PRELIMINARY PLANS
DO NOT USE FOR CONSTRUCTION

ROLESVILLE RD MIXED USE
1216 ROLESVILLE RD
ROLESVILLE, NC

SKETCH PLAN
C-1
SHEET 1 OF 1

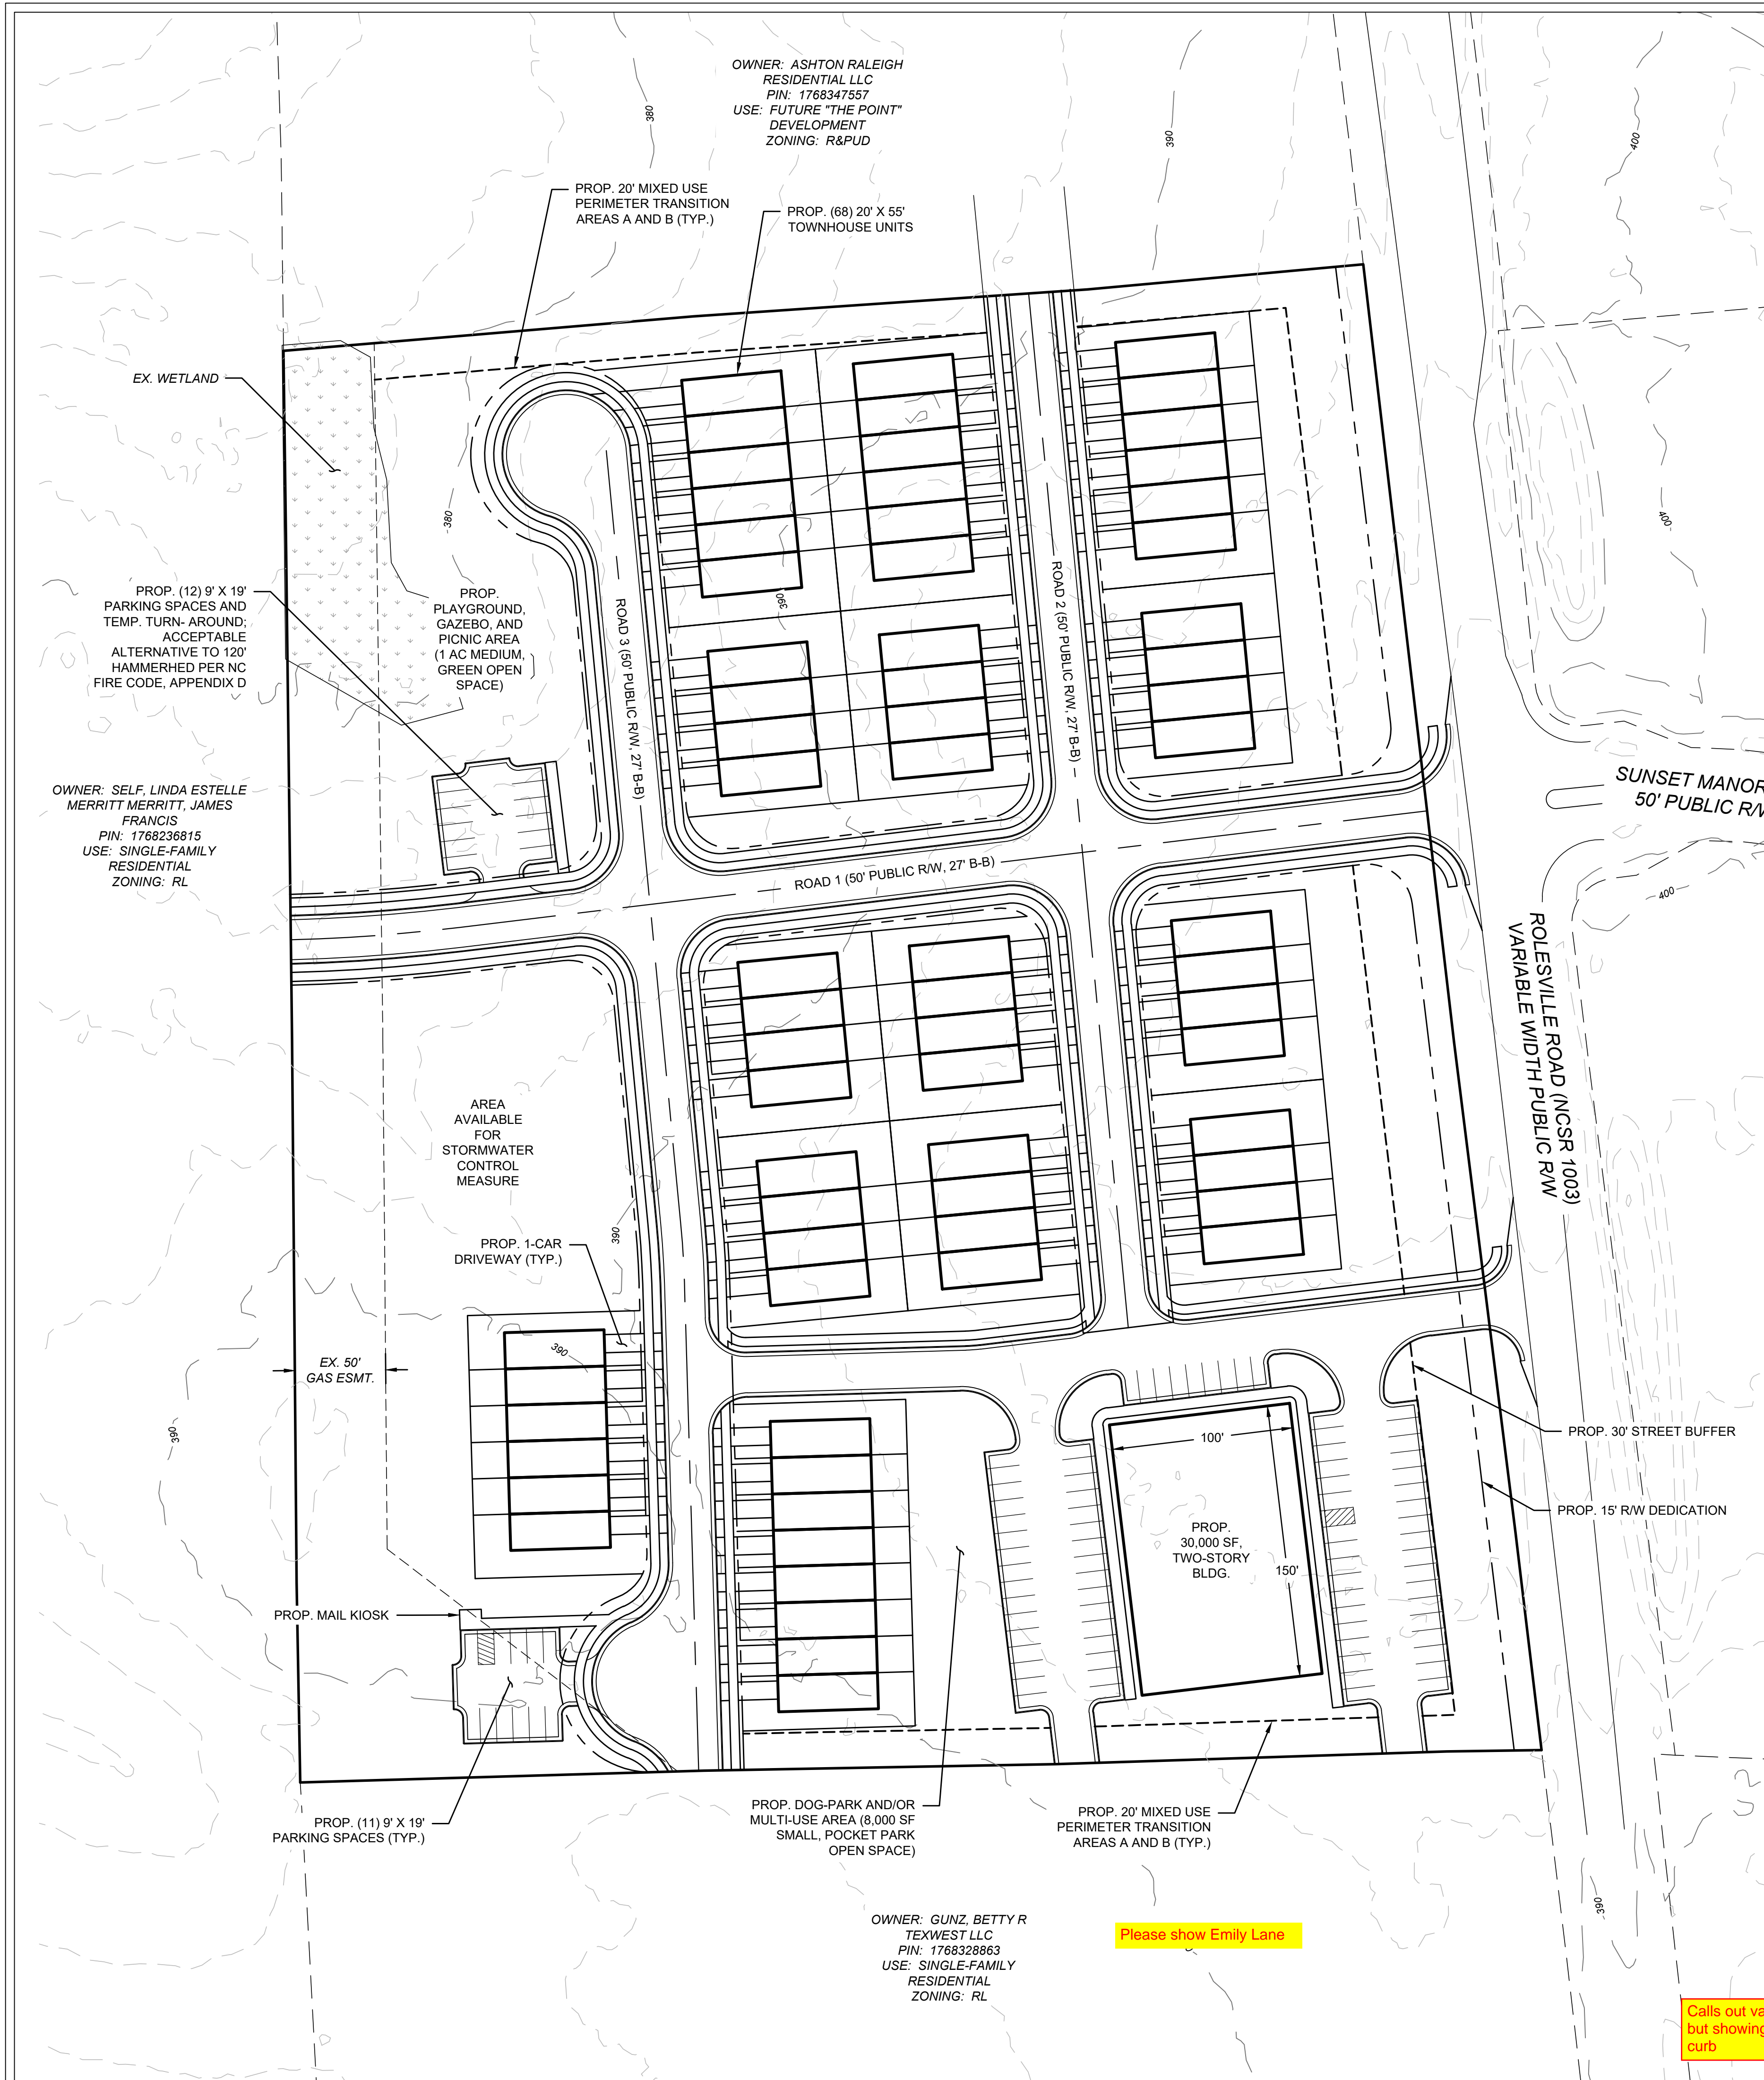
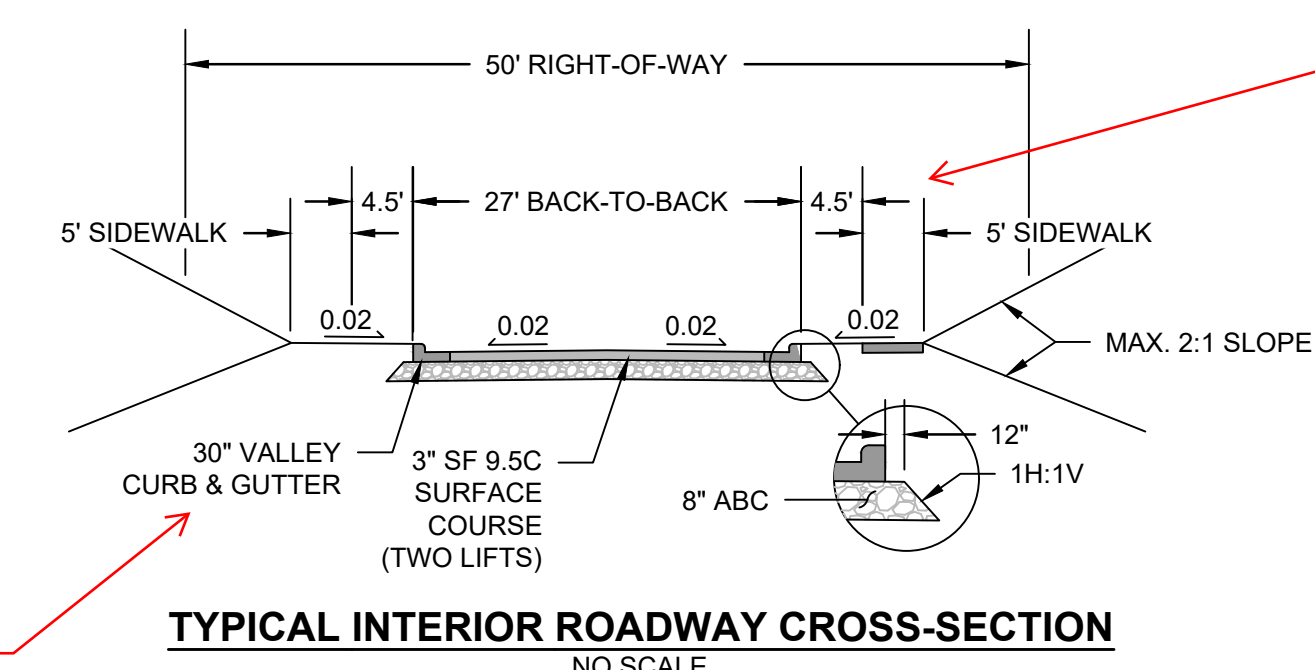
Bearing and Distances should be provided for the outer perimeter of the proposed property

ROW improvements will be required for the entire length of the property along Rolesville Road.

Will need a typical section for Rolesville Road showing the final ROW dimensions to confirm it matches the Town's CTP. Required on Preliminary Plat/Site Plan submittal. The distances between all intersections will have to be reviewed and ensure they meet DOT requirements. There is concern with how compact this site will be along Rolesville Road with the existing Sunset Manor Dr and Emily Lane, then adding 2 more intersections in the same segment.

All pedestrian ramp locations will be required to be shown for Preliminary Plat/Site Plan submittal.

Consider shifting the sidewalk 1' off the ROW to allow for a larger planting strip/boulevard; Not required to be corrected for this submittal approval

Calls out valley curb but showing standard curb

Please show Emily Lane
